ADDENDUM #1

RFP/RFQ # 7459230

TITLE: SOUTH BULKHEAD REPLACEMENT & SITE IMPROVEMENTS, PHASE I, DEM

Addendum No. 1
January 31, 2013
Galilee South Bulkhead – Phase I
Pier 3 Reconstruction
Page 1 of 3

EXISTING CONDITIONS PLAN

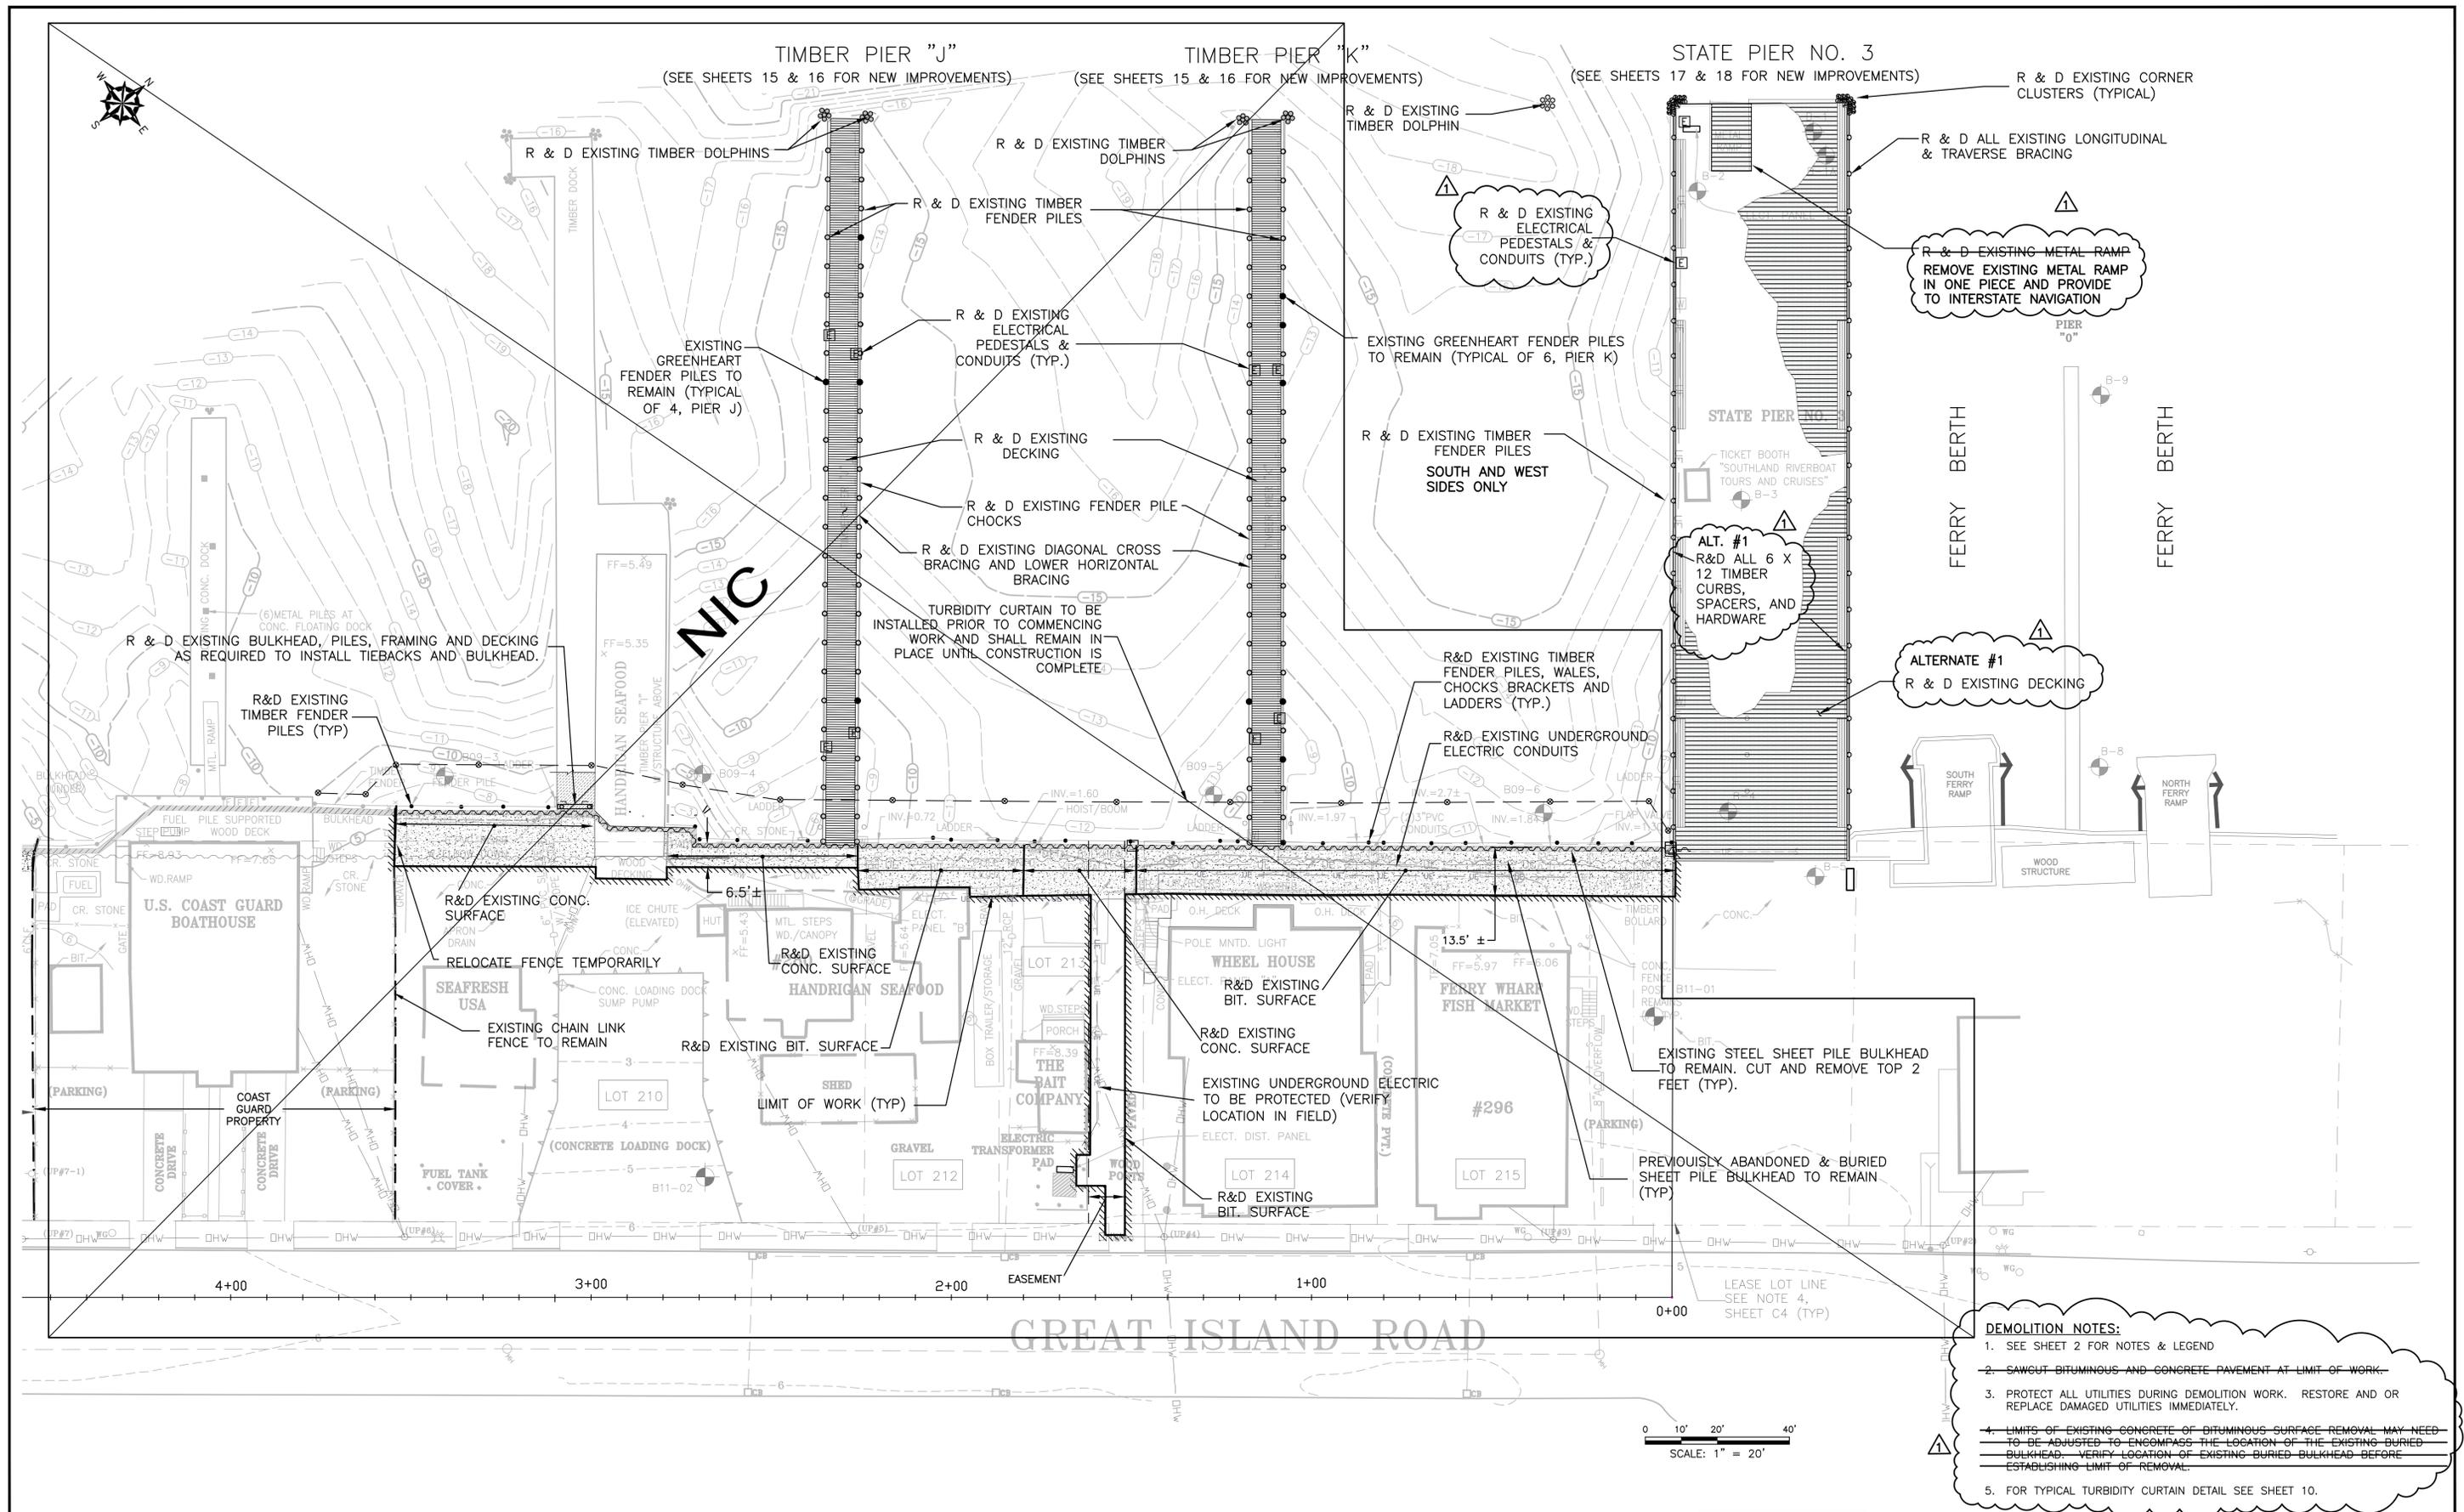
3. See the notes from the Pre-Bid meeting for clarification on access to the pier during construction, and the revision to Specification Section 01015 included with Addendum 1.
4. The finish deck elevation is shown on Sheet 3 “Existing Conditions”, and ranges from 5.07 to 5.57 feet NGVD (5.92 to 6.42 feet MLW). The top of the lower horizontal brace is approximately elevation 0.0 MLW.
5. The size of the deck spikes shall be increased to 60d.

PIER 3 IMPROVEMENT PLAN
SCALE: 1/8" = 1'-0"

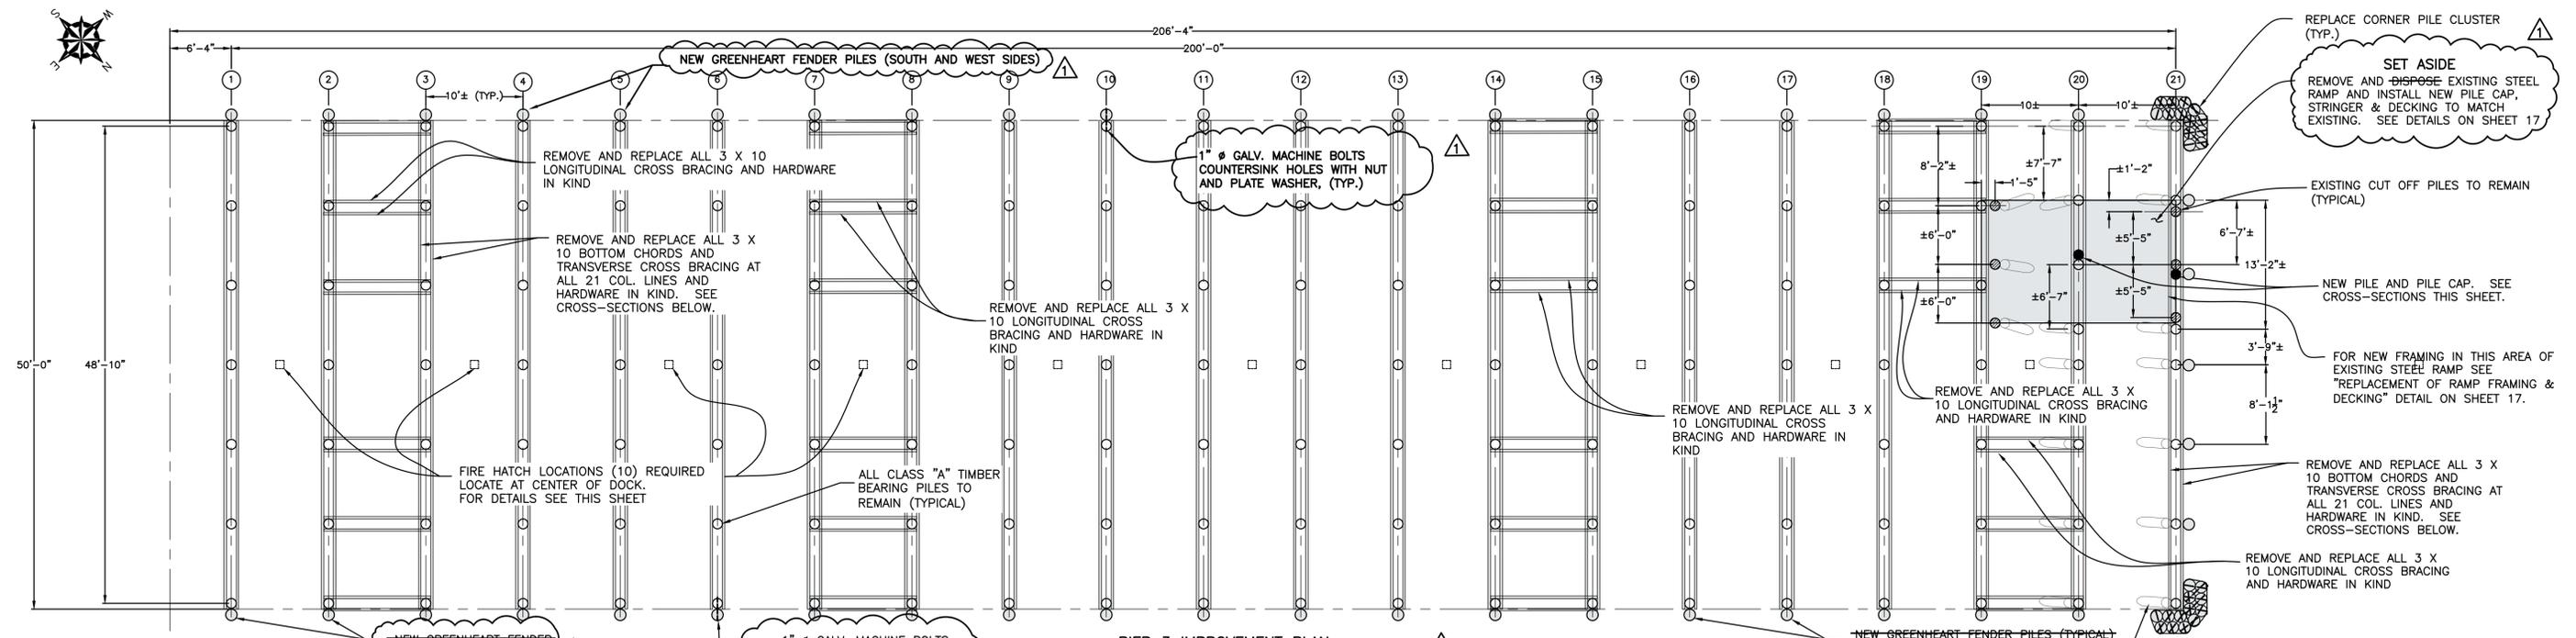
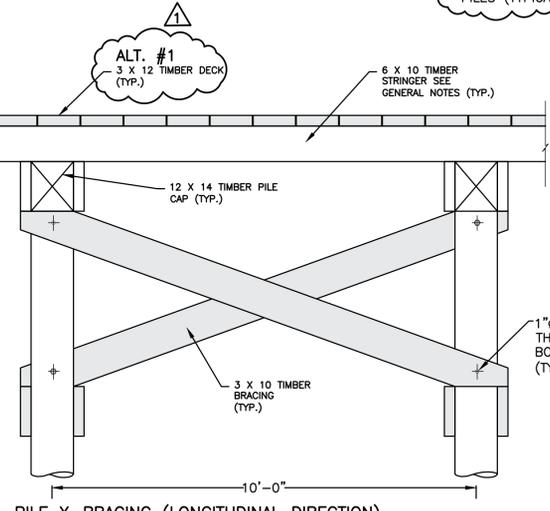
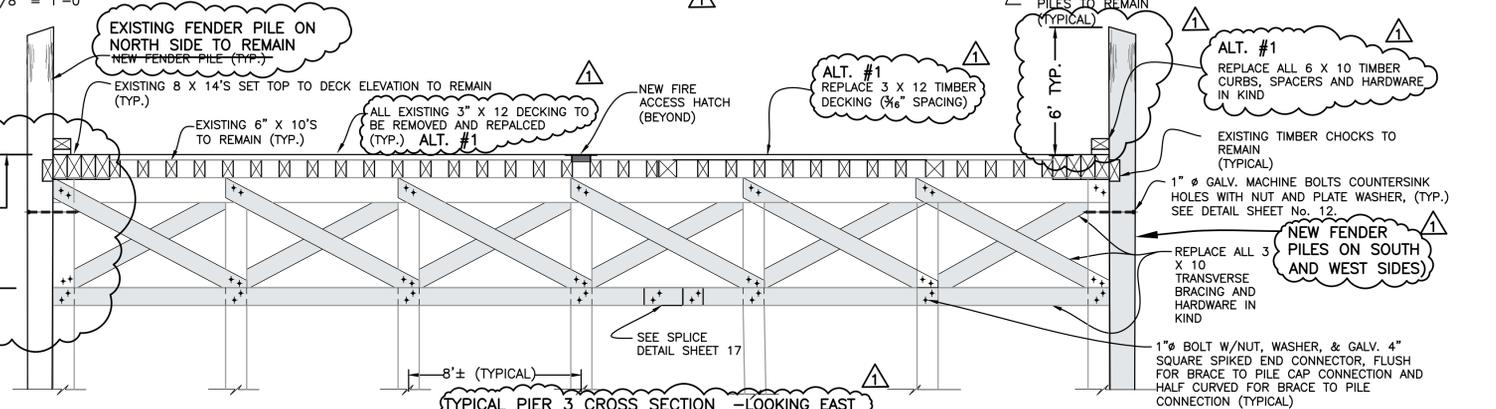
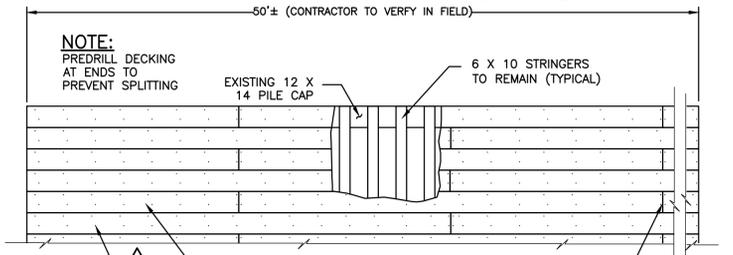
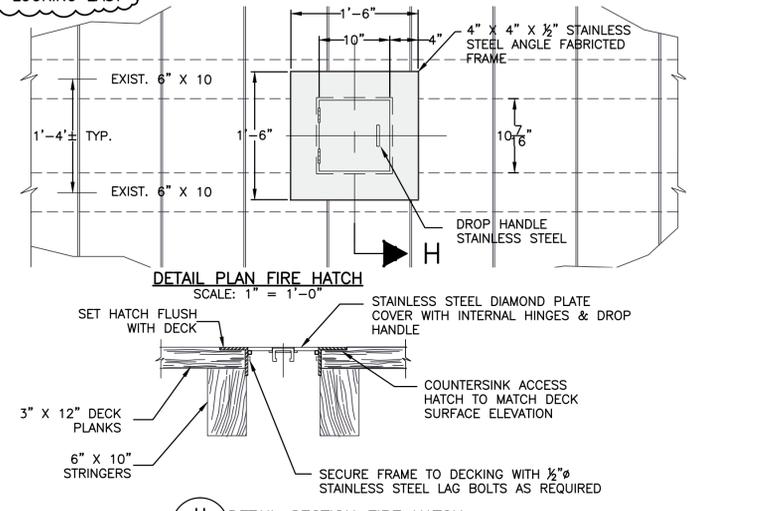
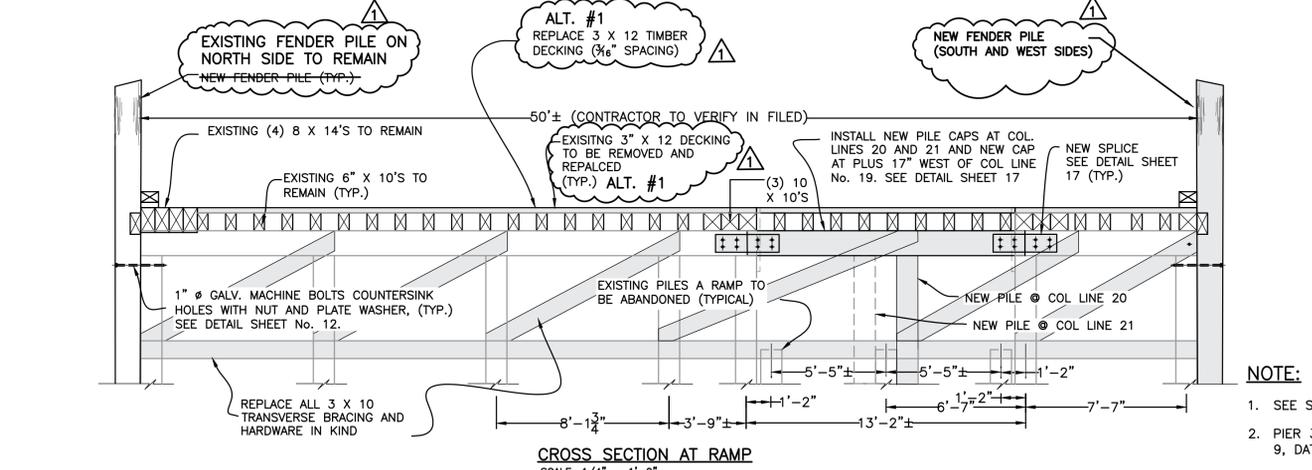
8. The spikes for the 3-inch decking shall be increased to 60d.
9. Interstate Navigation will remove the Jersey barriers and the wooden ticket booth from the pier.

A. **Alternate Number One:** Remove and Dispose all Existing timber decking and install new 3x12 timber decking (3/16" spacing) after the High Speed Ferry departs the pier on 10/17/2013 and before the High Speed Ferry returns to the pier on May 22, 2014. This Add Alternate includes all related work to installing the decking such as work to prepare the existing stringers, curbing, cleats, fire hatches, and tar paper. Removing and replacing the steel ramp will be part of the base bid.
